Subject: AP1000 Response to Request for Additional Information (SRP 9)

AP1000 TECHNICAL REPORT REVIEW

RAI Response Number: RAI-SRP 9.1.2-SEB1-05
Revision: 1

RAI Response Number: RAI-SRP 9.1.2-SEB1-06
Revision: 1

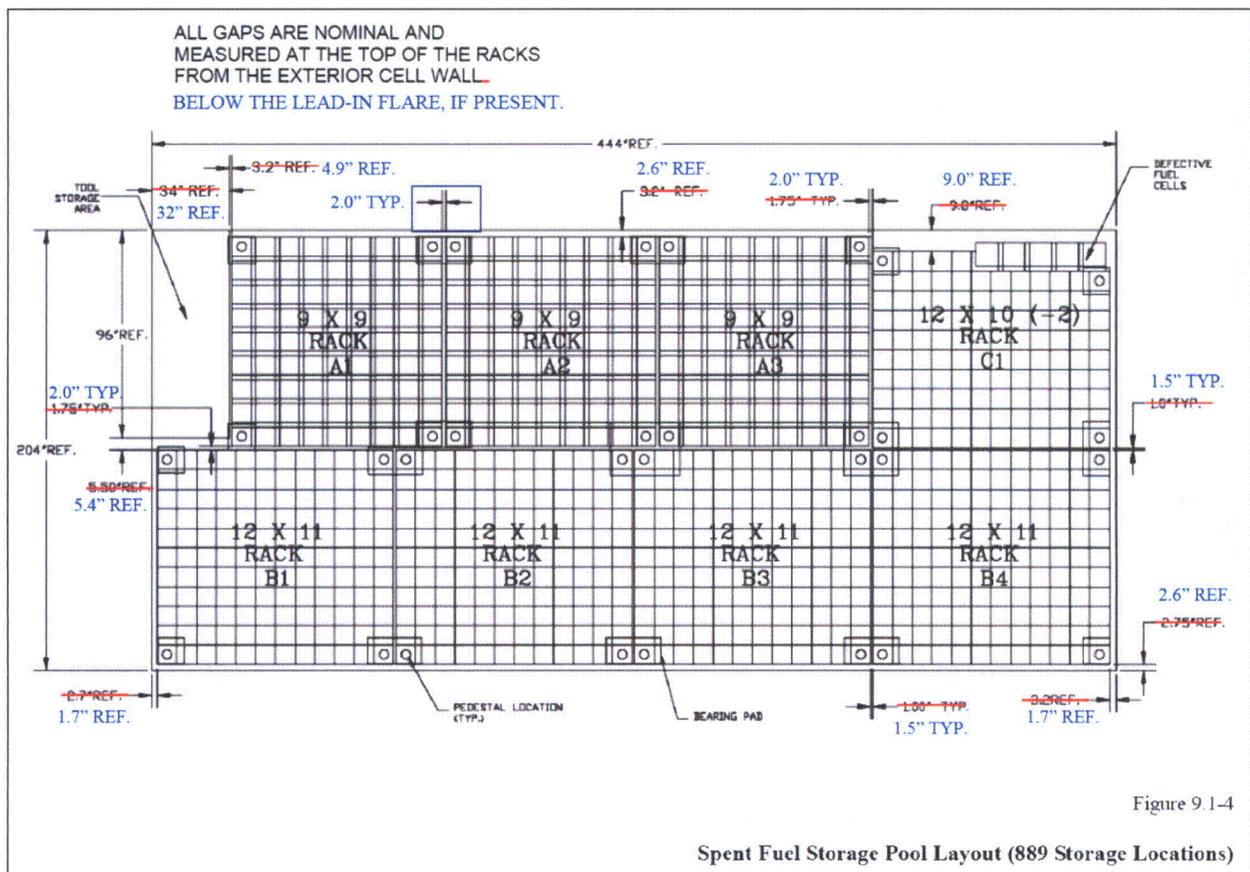
- The placement of the racks within the spent fuel pool is being modified to account for the aforementioned changes and to optimize the gaps such that the impacts (both rack-to-rack and rack-to-wall) are minimized. The slightly modified pool layout is shown in the markup of DCD Figure 9.1-4 on the following page.

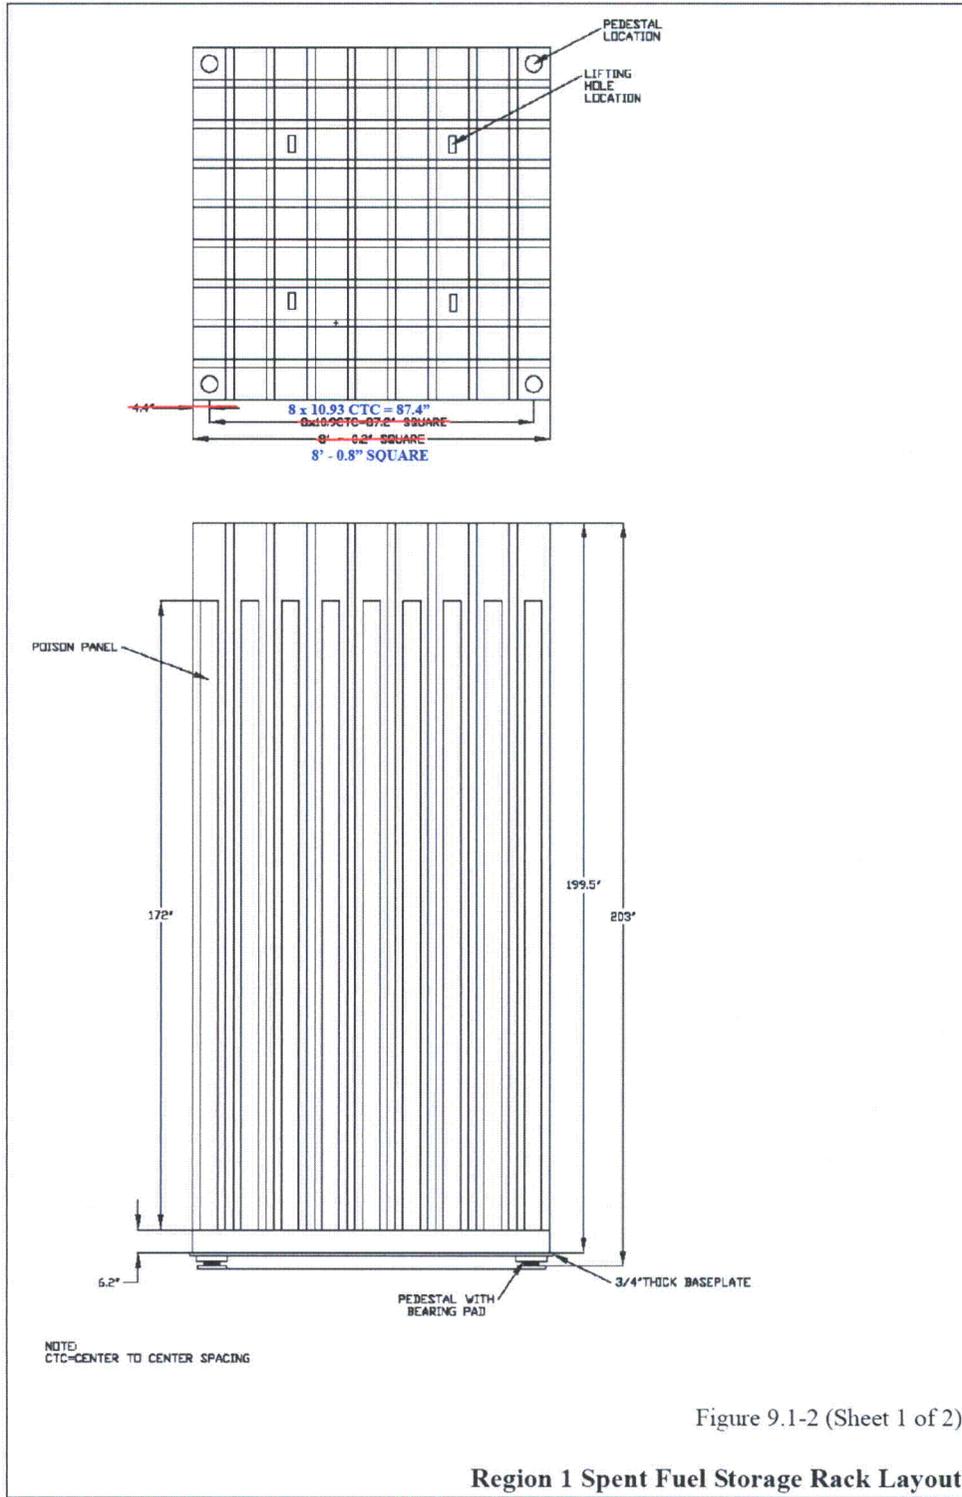
- Figure 9.1-2 (Sheet 1 of 2) of Rev. 17 of the DCD should be modified as follows:
 - The 4.4" dimension should be deleted, as it can be calculated from the other 2 dimensions provided, and it is inconsistent with the format of Figure 9.1-3.
 - 8x10.9CTC=87.2" SQUARE should be changed to 8 x 10.93 CTC = 87.4" SQUARE
 - 8' - 0.2" SQUARE should be changed to 8' - 0.8" SQUARE

• Figure 9.1-2 (Sheet 2 of 2) of Rev. 17 of the DCD should be modified as follows:

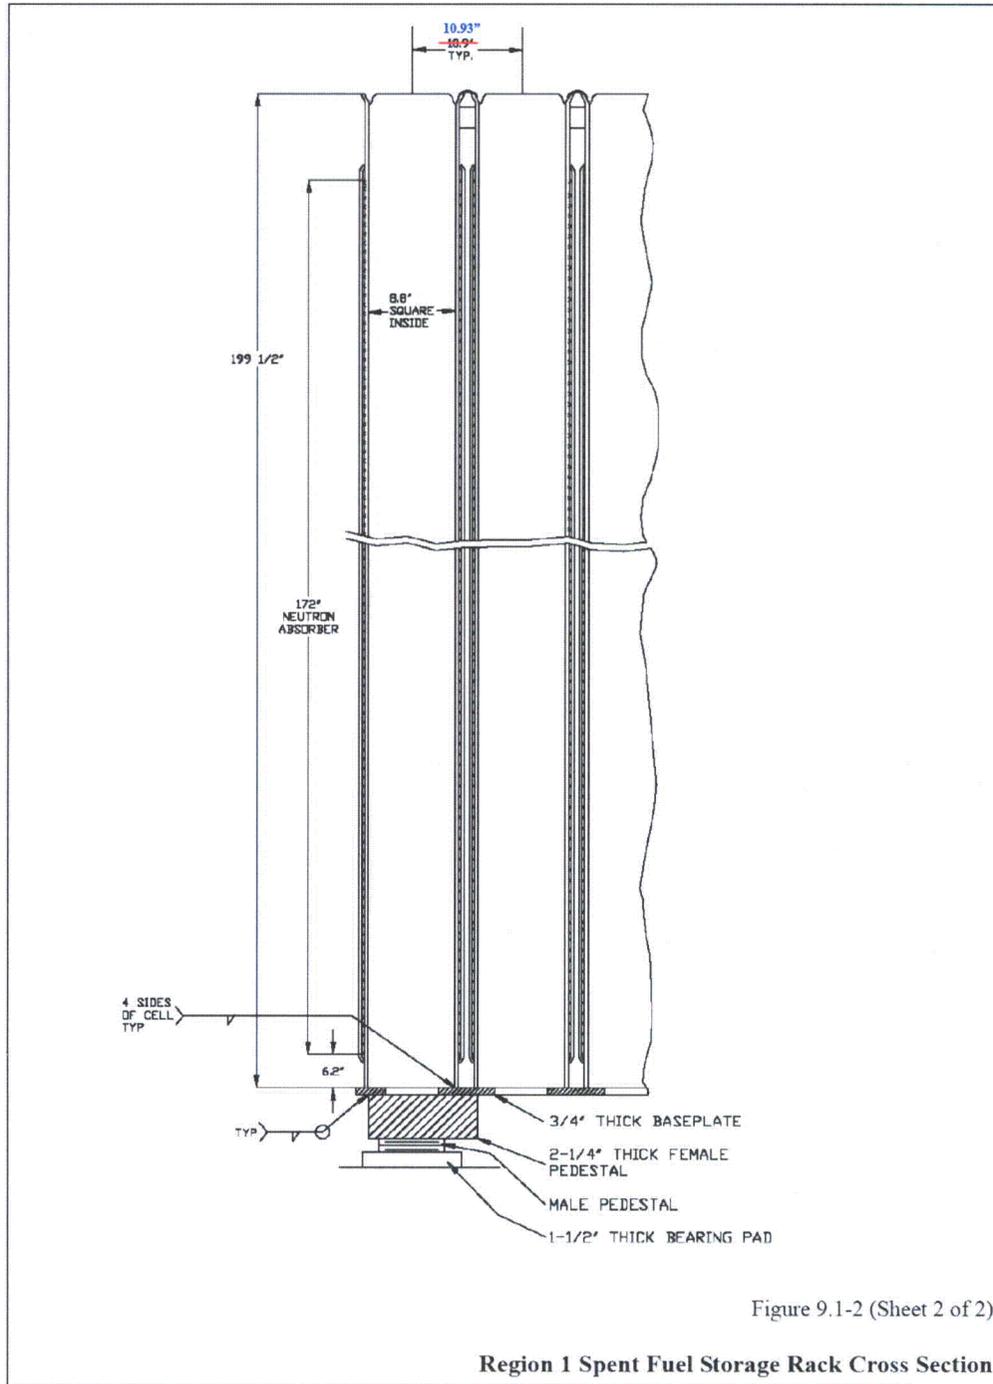
- 10.9" TYP. should be changed to 10.93" TYP.

• Figure 9.1-3 (Sheet 2 of 2) of Rev. 17 of the DCD should be modified as follows:

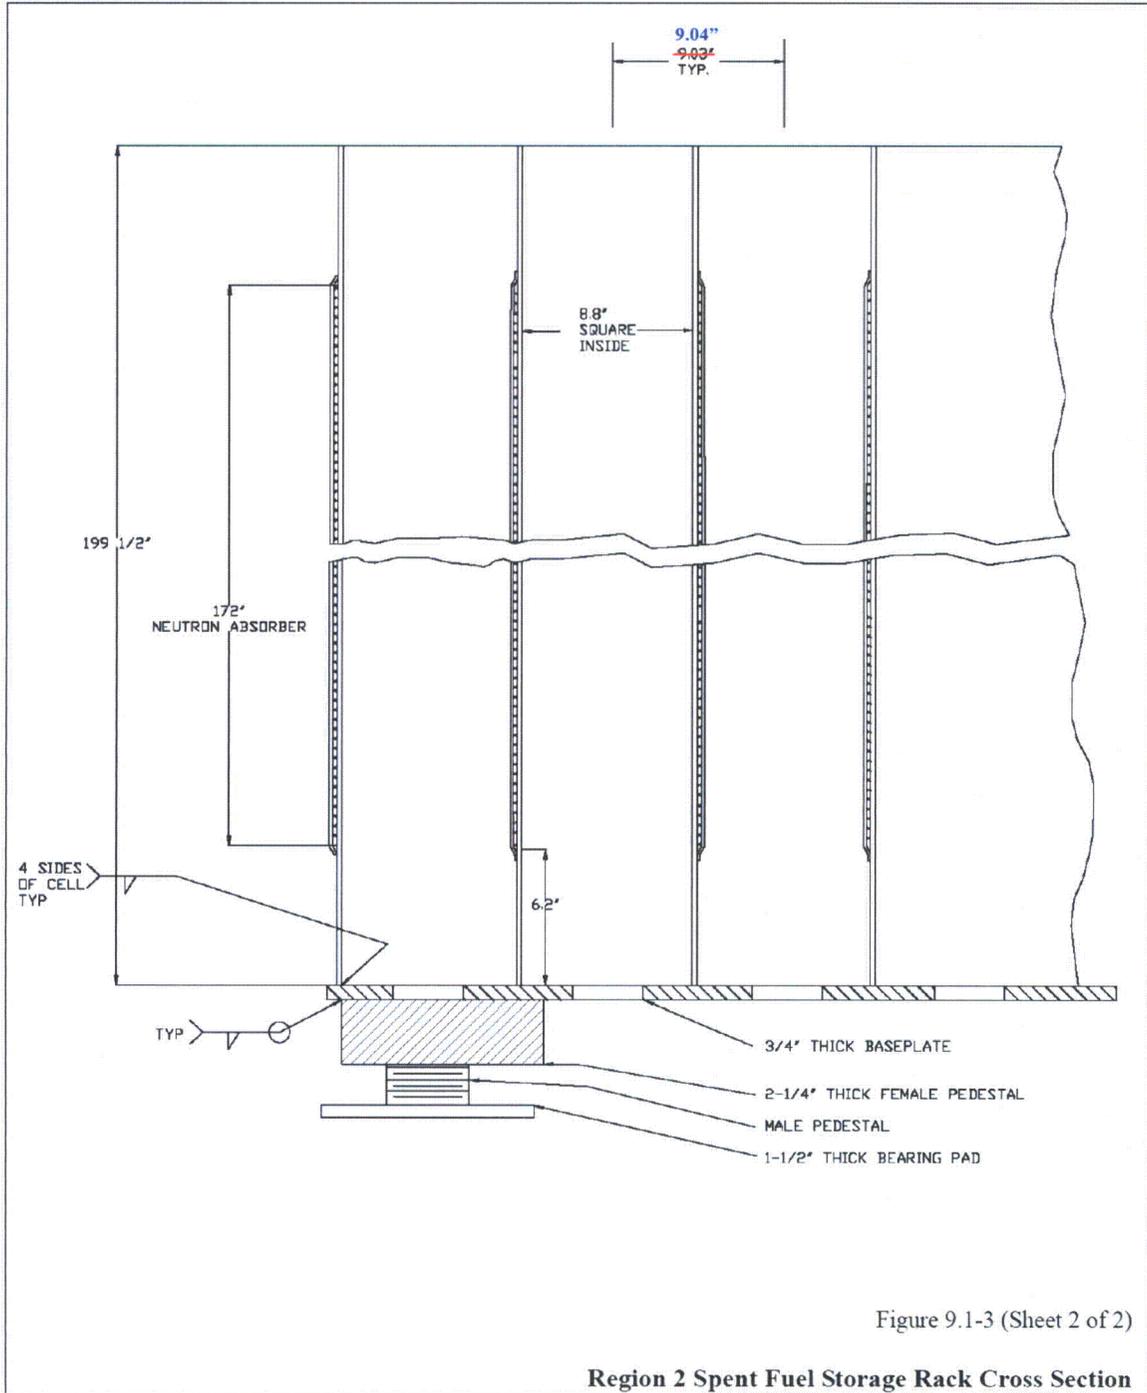
- 9.03" TYP. should be changed to 9.04" TYP.
